**ISSUE:** Permit to Demolish/Capsulate (partial), Certificate of Appropriateness for alterations, and Waiver of Fence Height

**APPLICANT:** Barbara and George Barlow

**LOCATION:** Old and Historic Alexandria District  
808 Duke Street

**STAFF RECOMMENDATION**

Existing & Proposed Rear Elevation

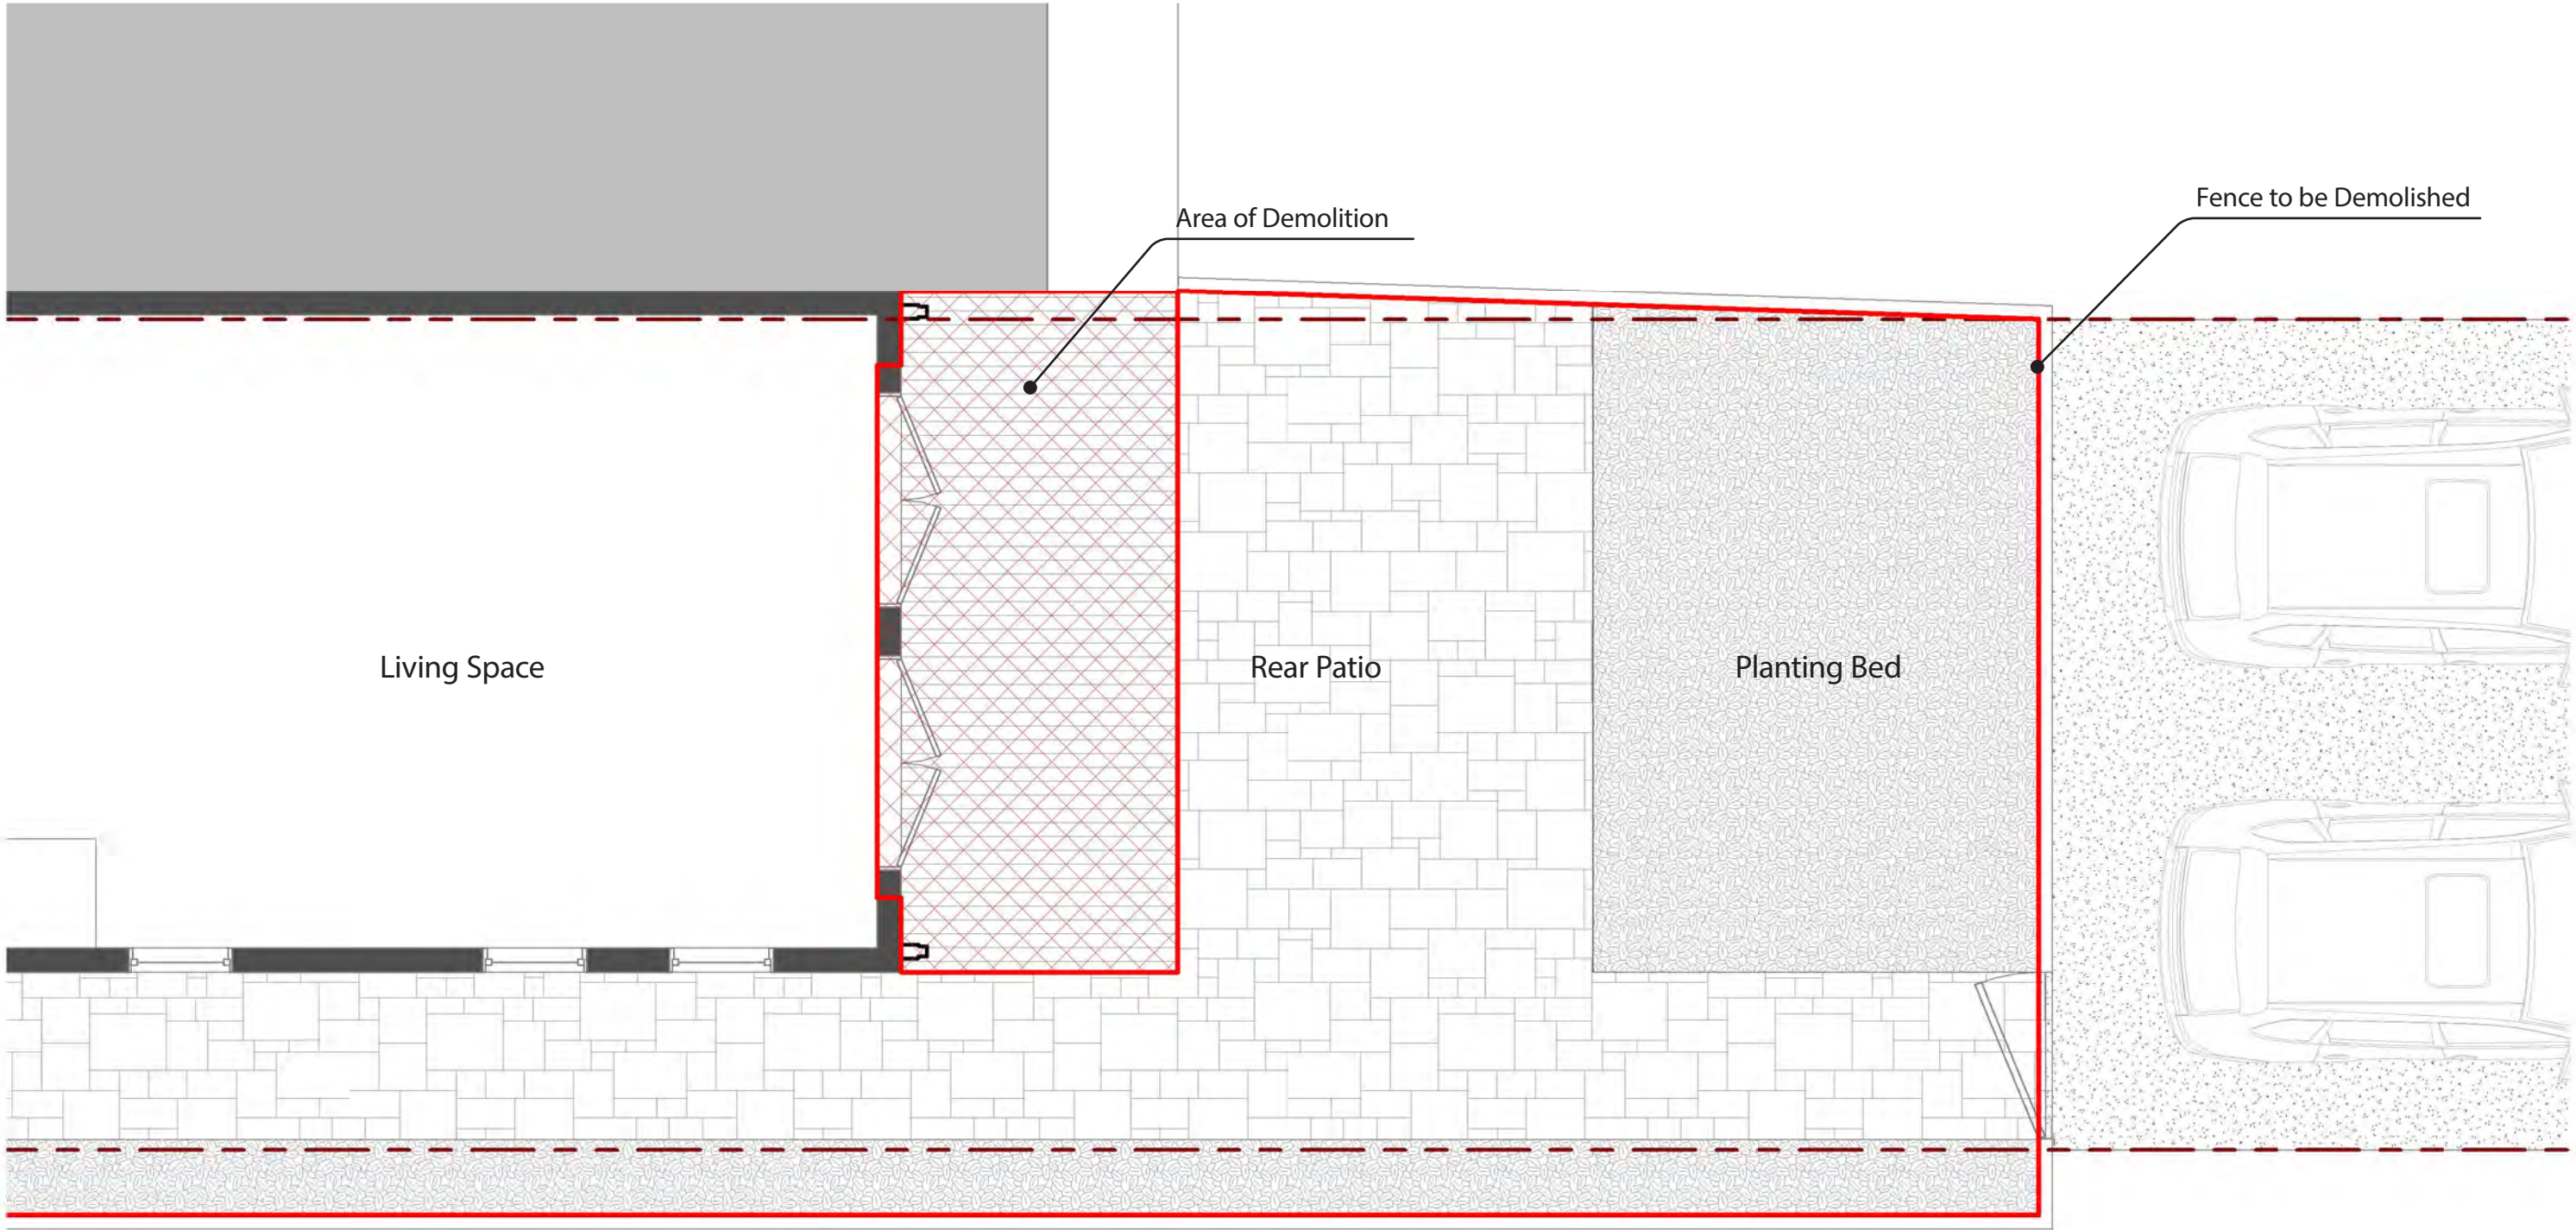
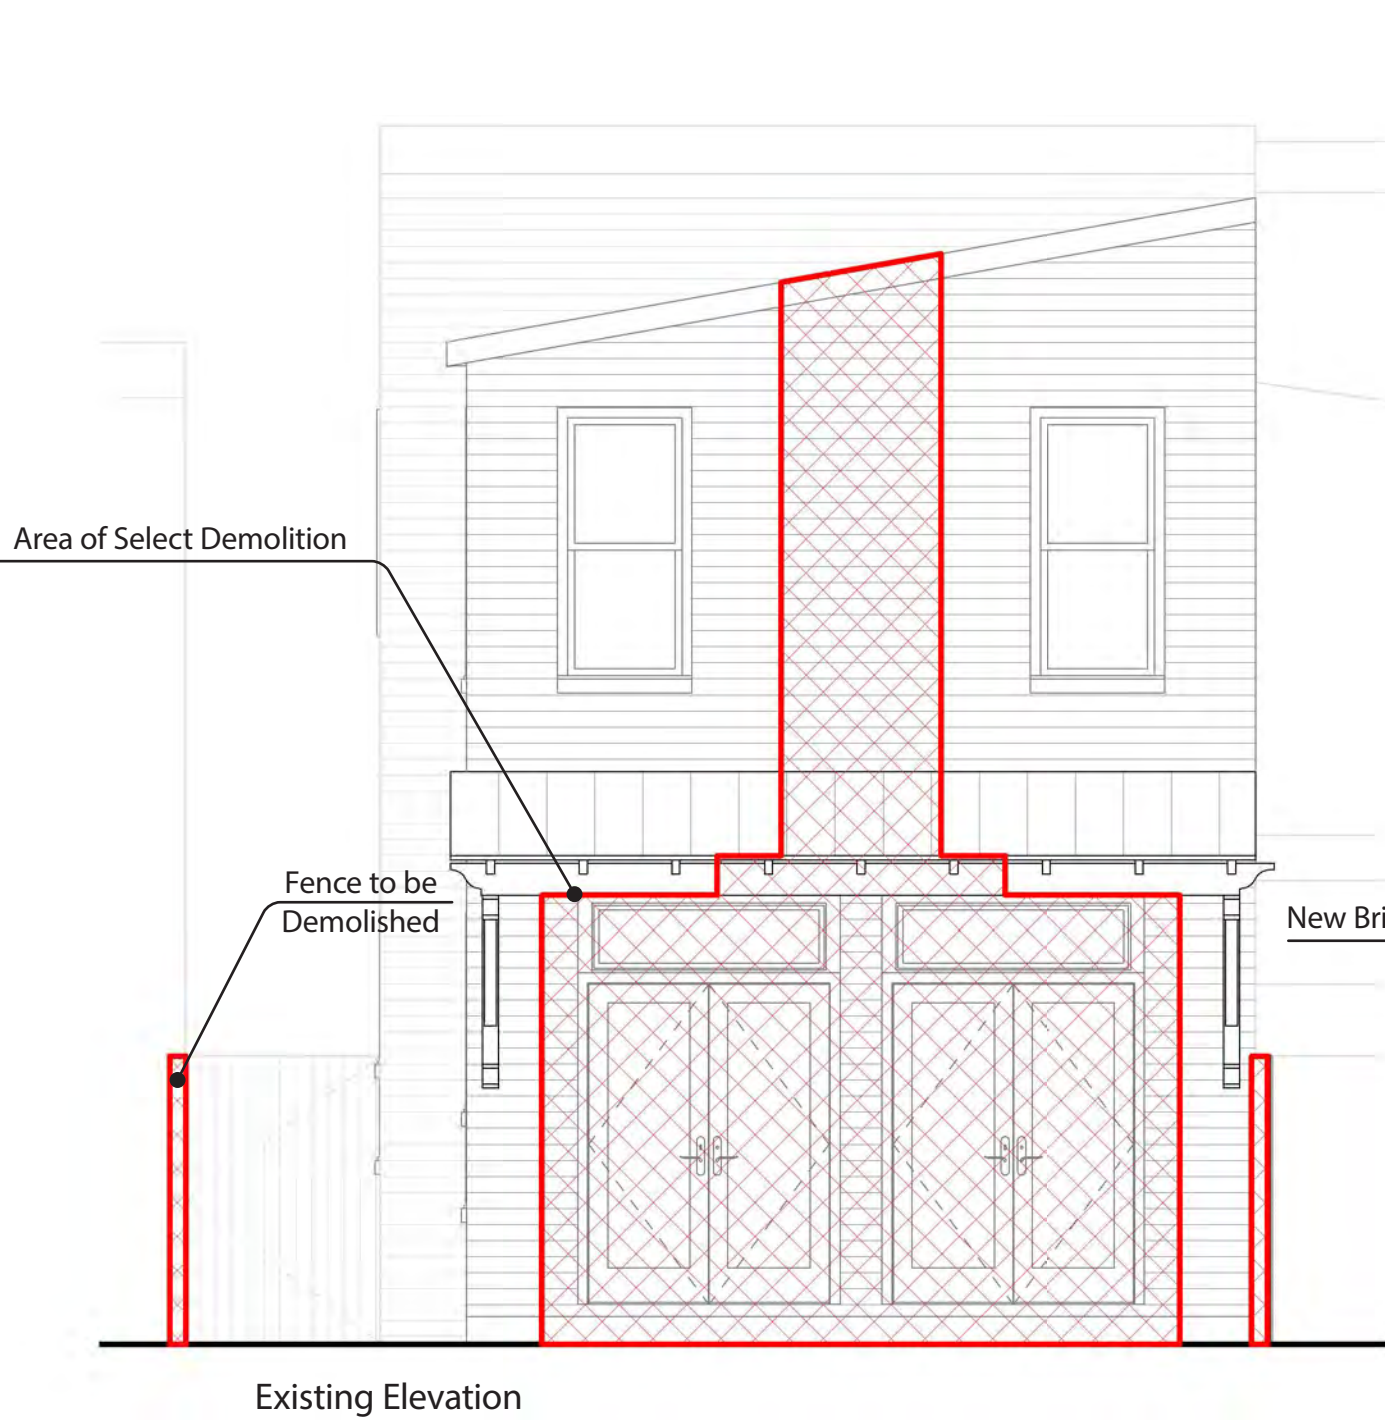
In the opinion of staff, none of the criteria for demolition and capsulation are met and the Permit to Demolish/Capsulate should be granted with conditions. The amount of wall area to be demolished/encapsulated (170sq.ft.) is limited to the rear elevation and will not significantly affect the architectural integrity of the building. Permit #23399, issued in 1966, approves replacing the bricktex siding with aluminum siding, therefore indicating that the material to be encapsulated is not original. Additionally, the alterations on the 1<sup>st</sup>-story will be minimally visible because of the rear fence. Portions of the chimney will be visible from the public alley.

Staff, therefore, recommends approval of the Permit to Demolish/Capsulate as submitted.

Proposed East Elevation

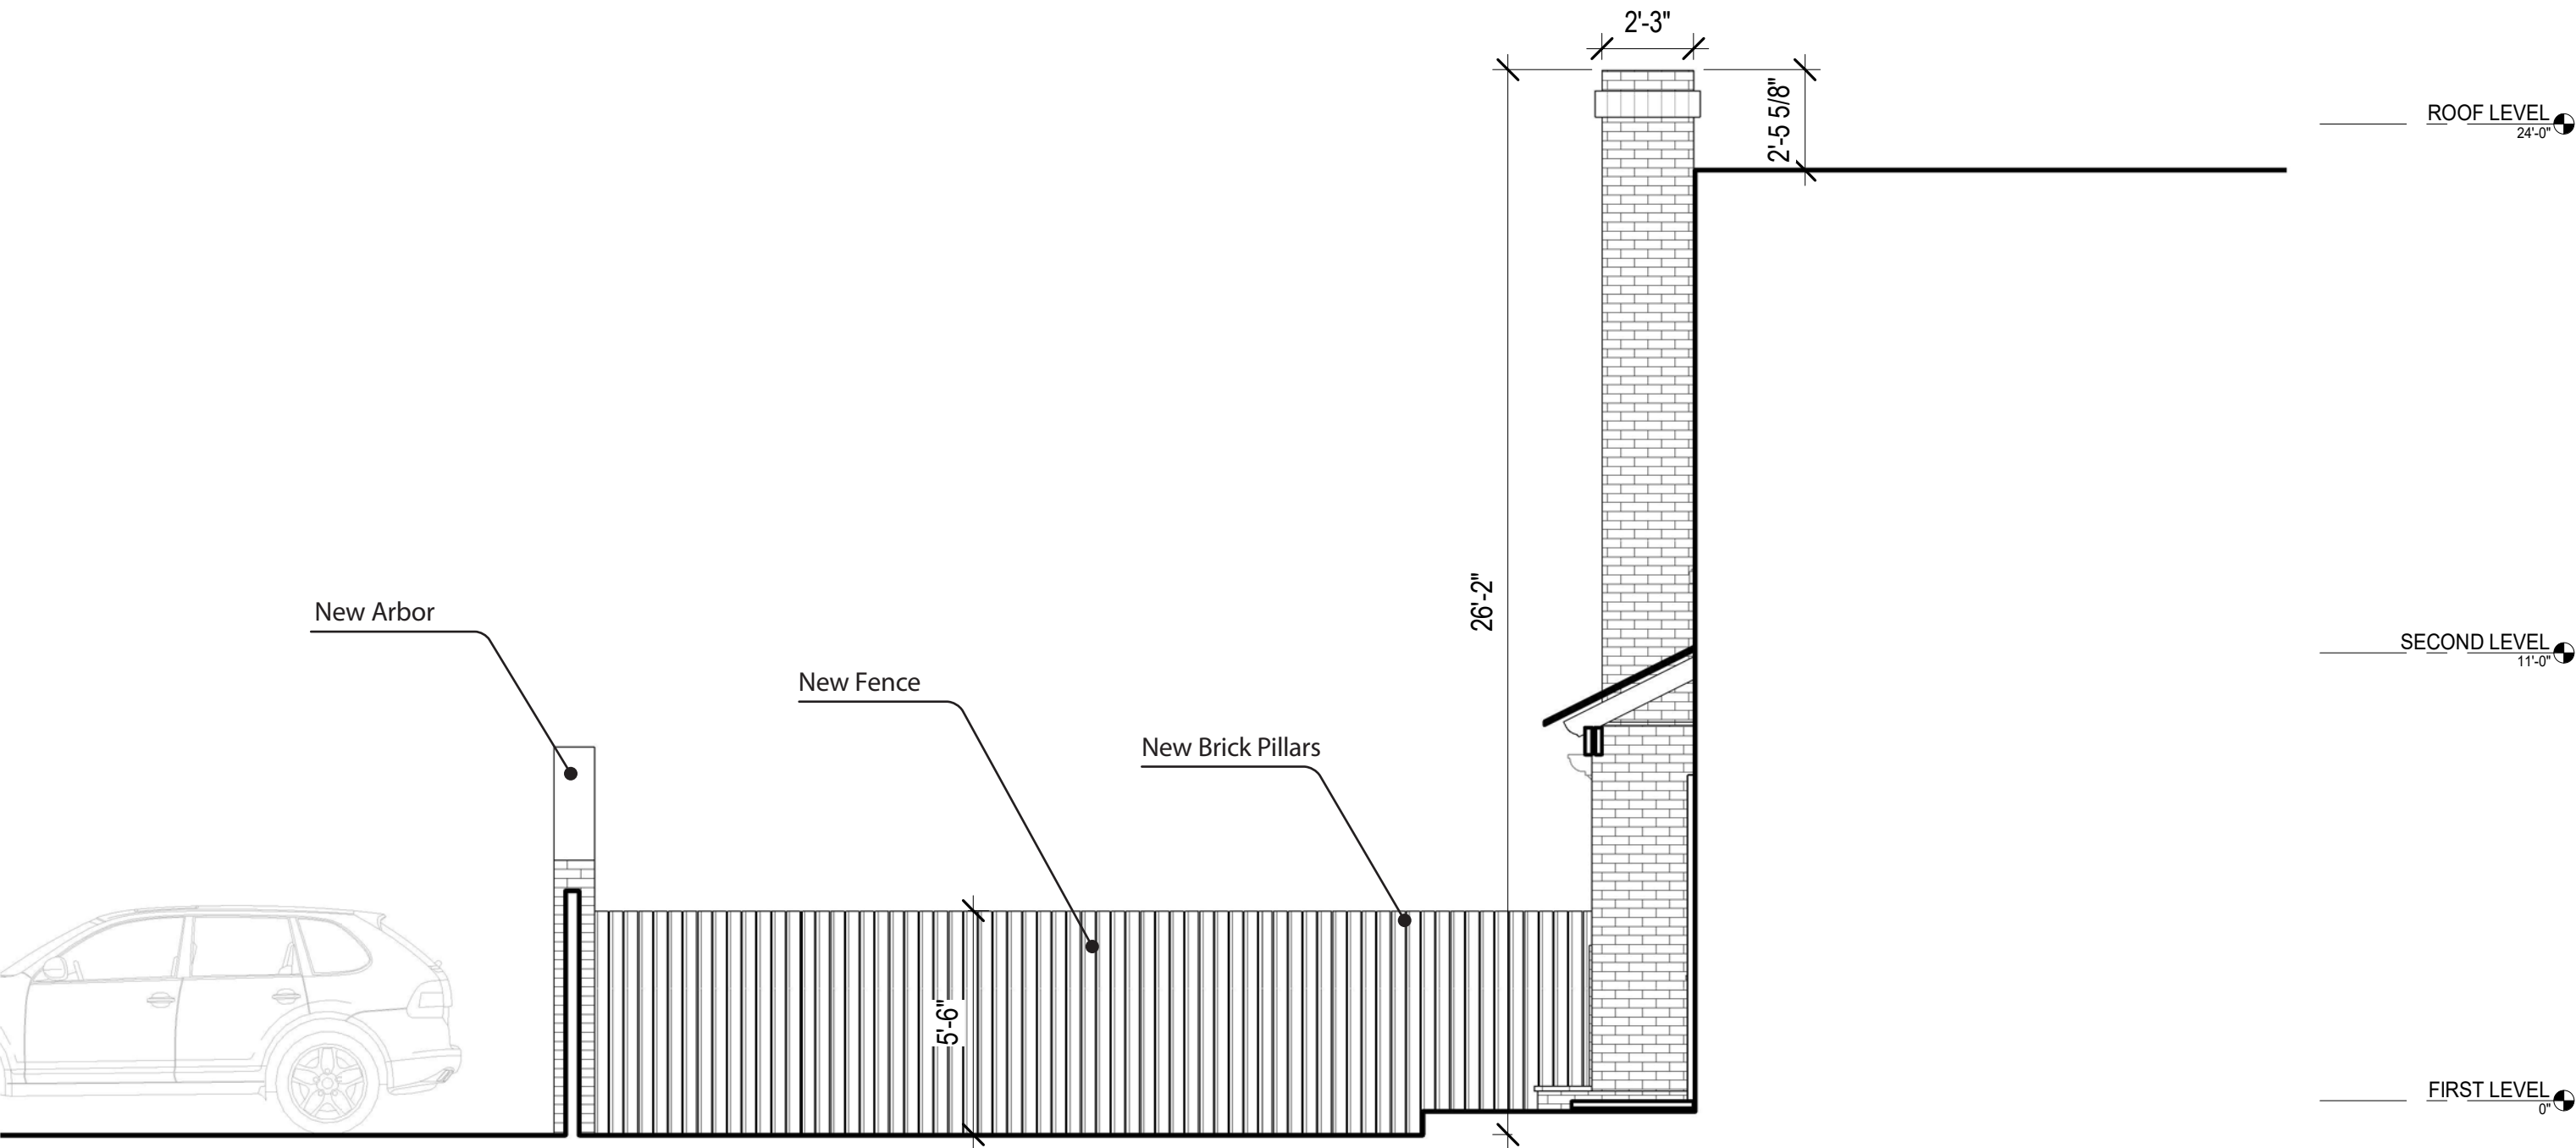
composition of the building. The proposed outdoor fireplace and chimney are architecturally appropriate and do not cause a visual disruption of the unified building design.

The two pairs of existing double doors will be converted to two single eight-pane doors. Doors, like windows, are a principal character defining feature of a building and serve both functional and aesthetic purposes. The design and configuration of the proposed new doors are architecturally appropriate. The glazing for the new doors must meet all the *Alexandria New and Replacement Window Performance Specifications in the Historic Districts* criteria.

1. The glazing for the new doors must meet all the *Alexandria New and Replacement Window Performance Specifications in the Historic Districts* criteria; and,

Proposed Fence Elevations - Options A & B

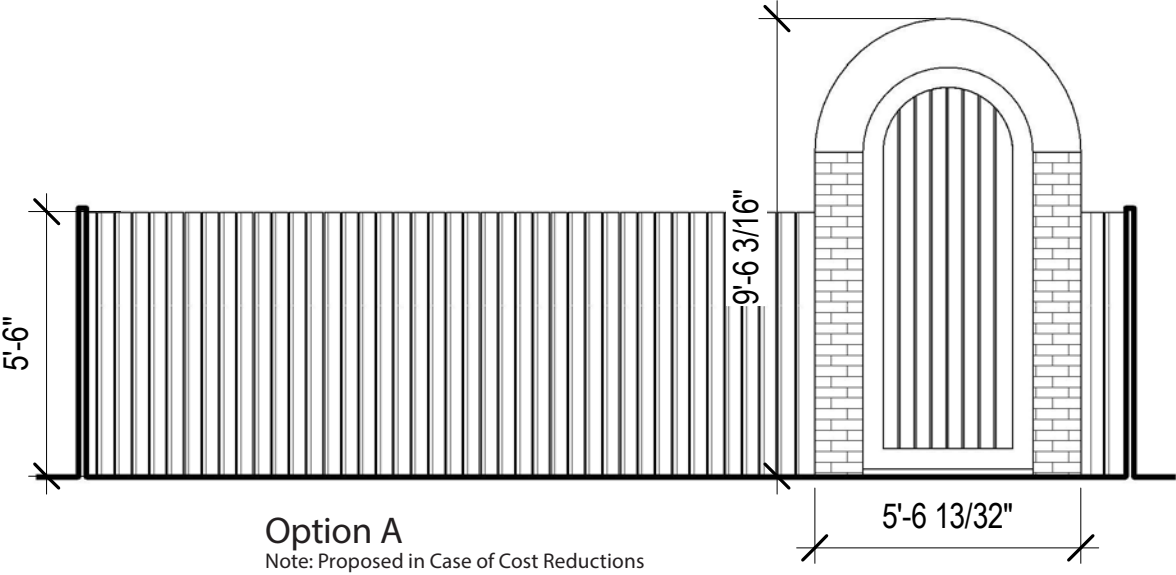
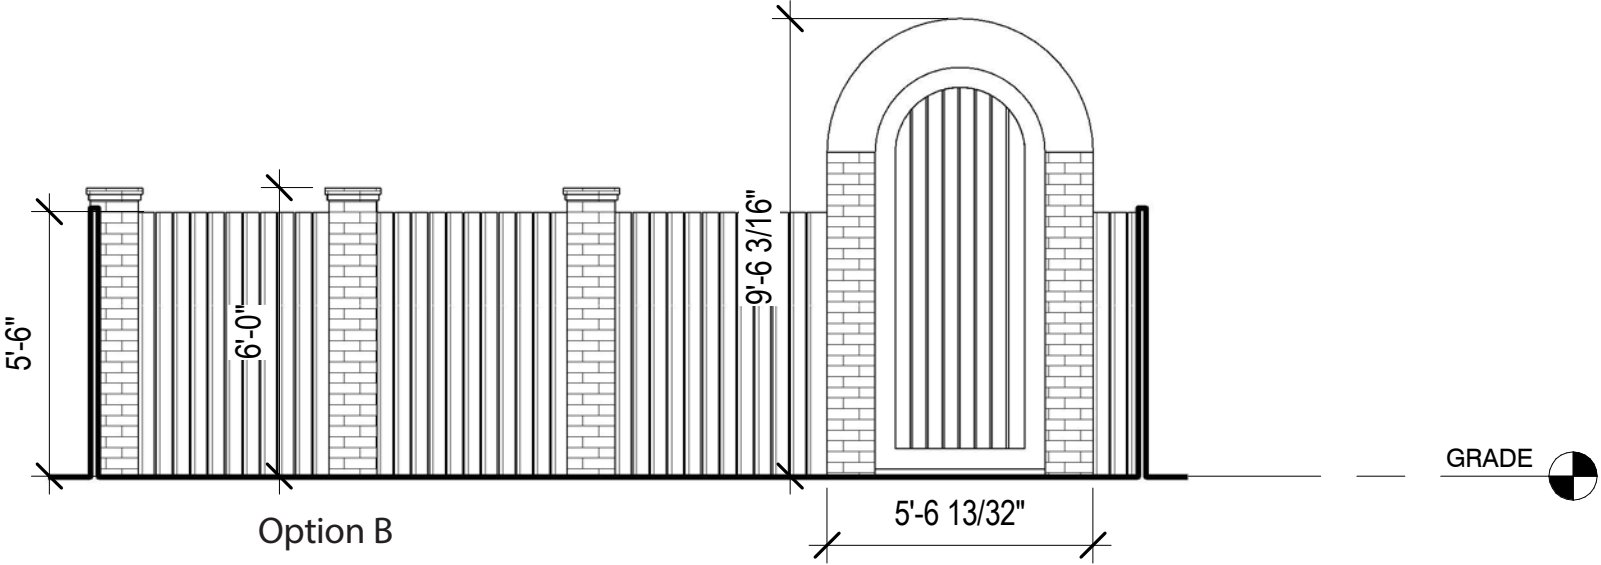
Staff has no objection to the proposed alterations, which are minimally visible and will have little effect on the historic fabric of the property. Staff also supports the waiver of fence height, as it is limited to the proposed gate. The proposed gate will be 5'-6" wide and 9'-6" in height. The remainder of the fence will not exceed 6'-0" in height. The two fence options submitted are both architecturally appropriate and comply with the administrative approval policy. Both options include a painted wood fence with brick pillars flanking the gate. Option B includes intermediated brick pillars within the painted wood fence.
